**Lift and Escalator Industry Association**

**MODIFICATION TO MARRYAT & SCOTT ELECTRO-HYDRAULIC F.A.P.B.,  
TWO FLOOR U.S.E. PUMP AND MAXTON VALVE, STAR/DELTA STARTING,  
WITH HARRIS PREBLE SHUTTER GATES**

KONE LIFTS LTD	Subject <u>Modification to Marryat &amp; Scott Electro-Hydraulic F.A.P.B. Two Floor U.S.E. Pump &amp; Maxton Valve, Star/Delta Starting, with Harris Preble Shutter Gates. Ref: Drawing IO 3673</u>				CODE: SN 10.01.05
					Pages: 1 OF 5
					SAFETY CATEGORY A
DEPT. TECH.SUPP	DATE 22.1.98	COMPILED BY A J Shiner	CHECKED V J Kaura	APPROVED <i>Asstle</i>	ISSUE A

**Modification to Electro-Hydraulic F.A.P.B. Two Floor U.S.E. Pump & Maxton Valve, Star / Delta Starting, with Harris Preble Shutter Gates. Ref to Drawing LO 3673.**

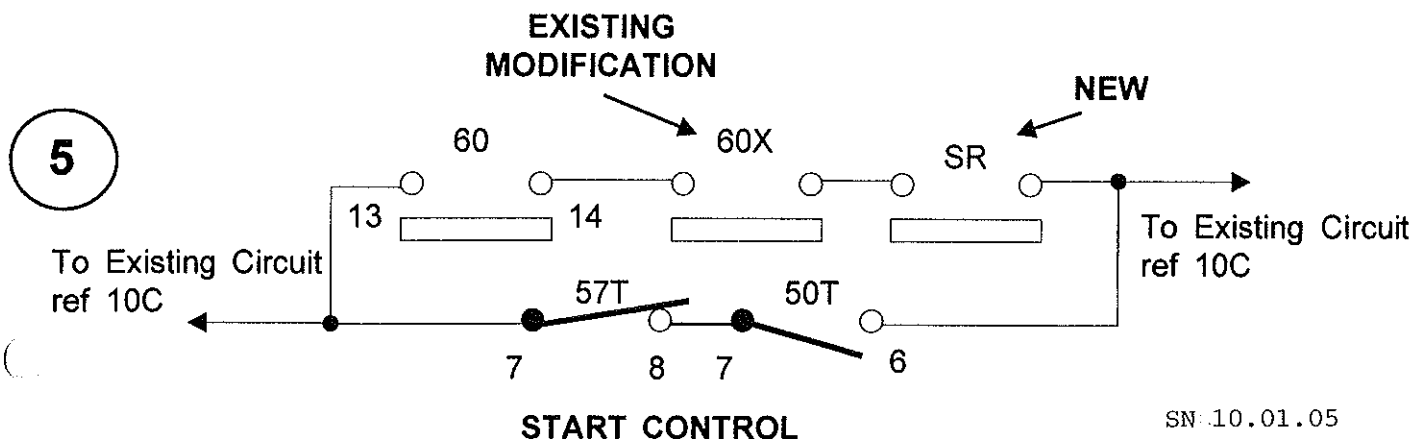
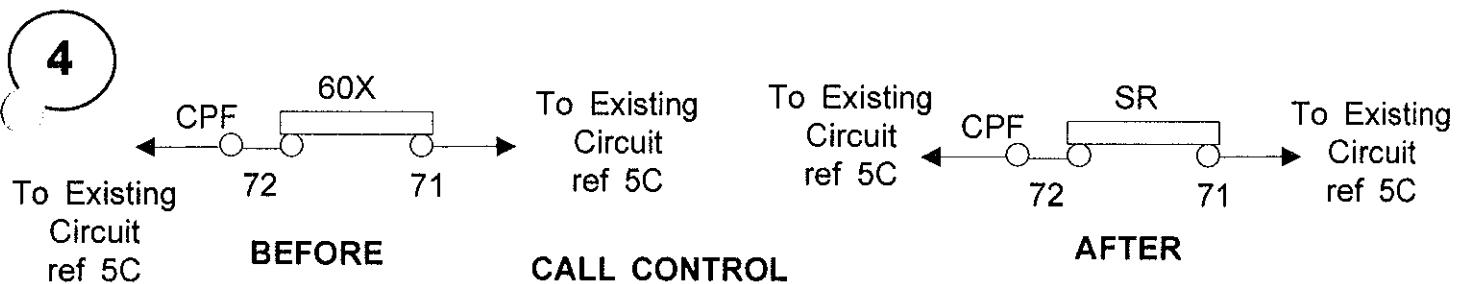
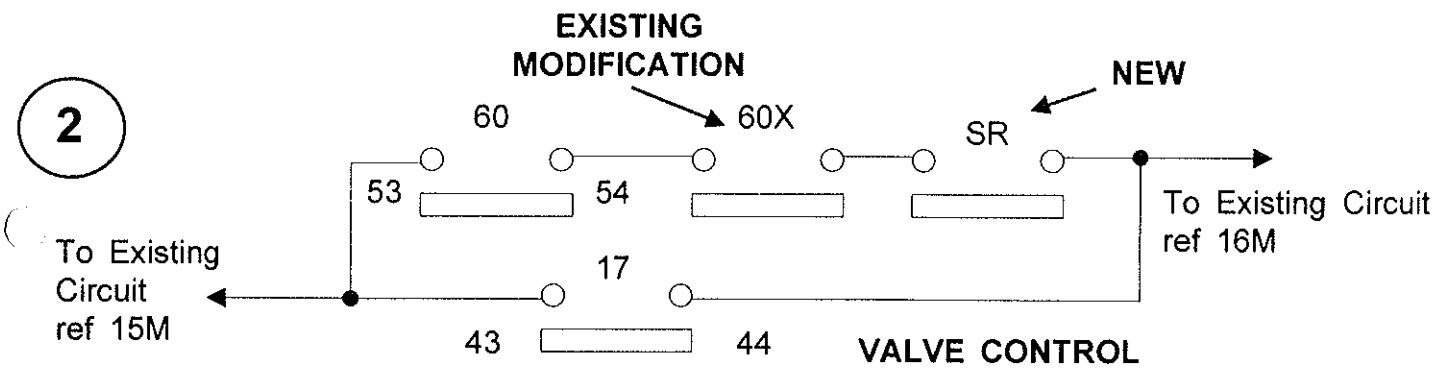
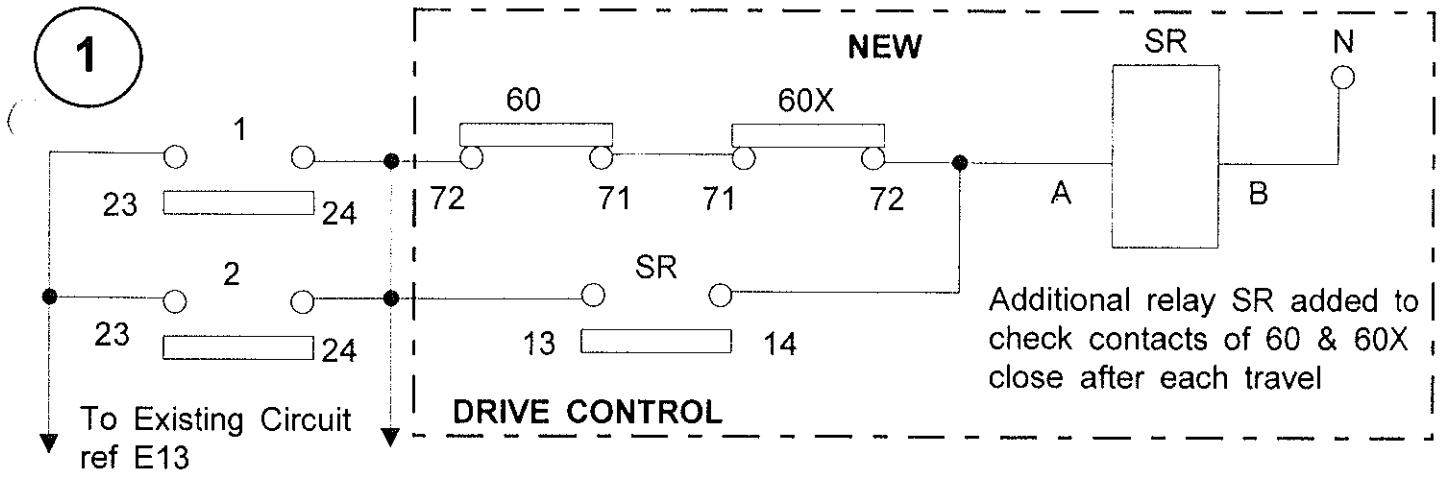
**Stage 1** Addition to the circuit feeding Relays 60 & 60X.

Relay SR added and contacts of 60 (72-71), 60X (71-72) & SR (13-14) wired as shown.  
When ever a new call is allowed relays 1 or 2 energise, provided both 60 & 60X have dropped out from the last travel relay SR (Safe Relay) will energise. The contact of SR maintains itself for as long as relays 1 or 2 remain energised.

**Stage 2** Addition of SR contact to the Valve Control circuit.

A modification has already been carried out adding a contact of 60X in series with relay 60 (53-54).  
Add an additional contact of SR in series with 60X & 60 as shown, making sure relay 17 (43-44) overconnects all of the 60X, 60 & SR contact.  
All 60X, 60 & SR contacts must energise before the Valves can operate.

**Stage 3** Addition of SR contact to the Star Delta Control circuit.

Add an additional contact of SR in series with 60 as shown, making sure relay 17 (33-34) overconnects both the 60 & SR contact. Both, 60 & SR contacts must energise before the Star Delta Control can energise.

KEY DIAGRAM  
 STAR DELTA STARTING, HARRIS PREBLE SHUTTER GATES

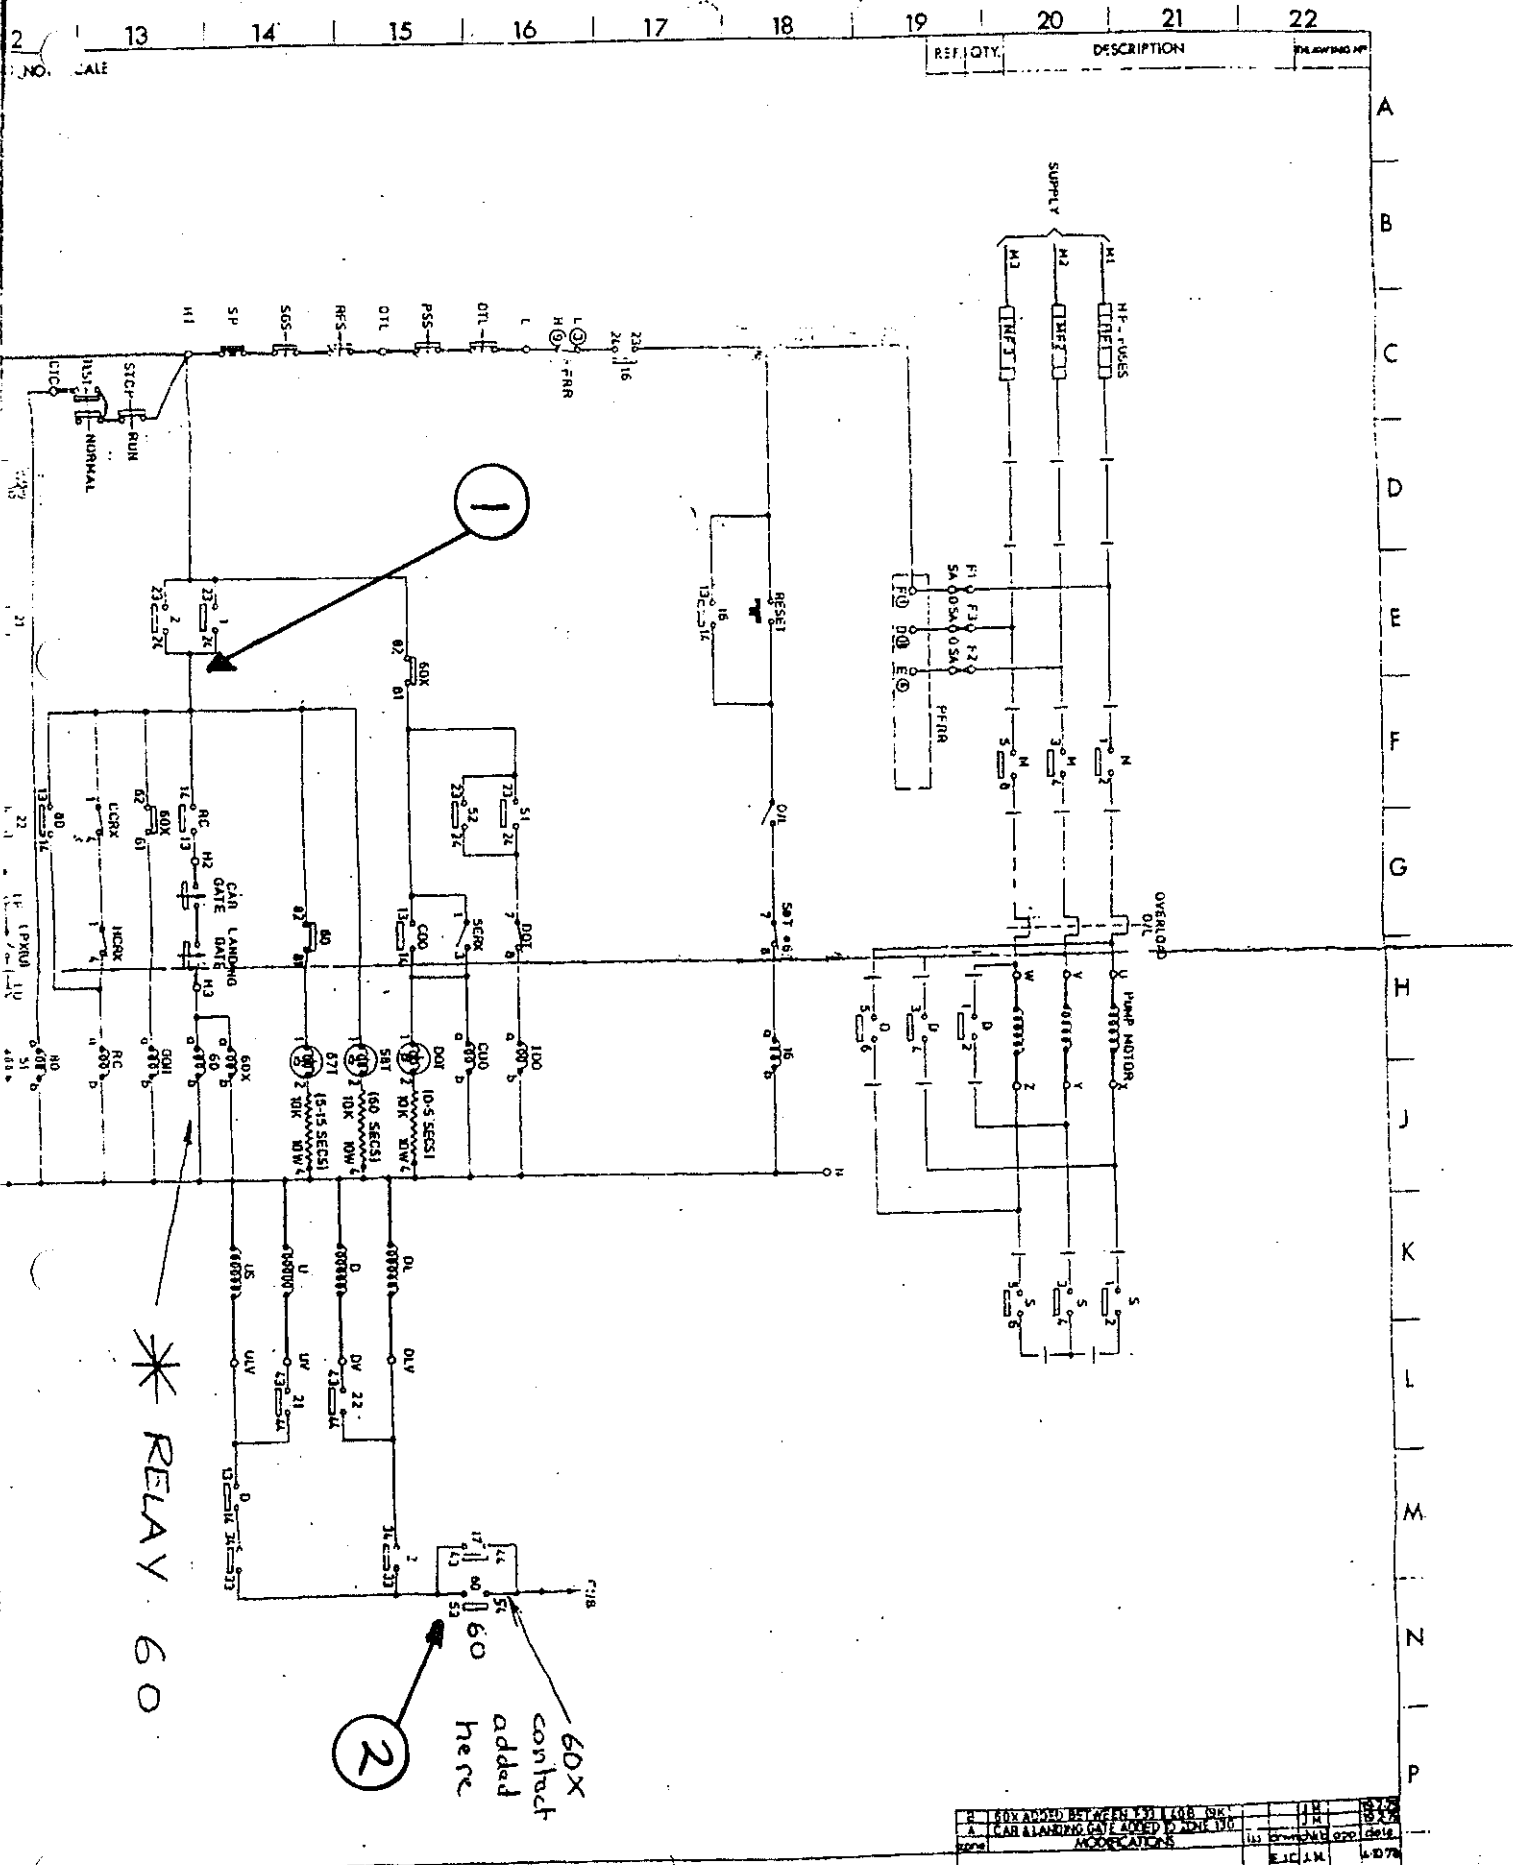
**Stage 4** Change of 60X (72-71) contact to a SR contact in the Call Control circuit.

By changing this contact it is not possible to move to a new call if the SR relay 'sticks IN, but Releveling is still possible.

**Stage 5** Adding additional contact of SR to the Start Control circuit.

If 60 or 60X remain energise it is not possible to move as the SR relay will not be energised.

\* RELAY 60

60X added contact here
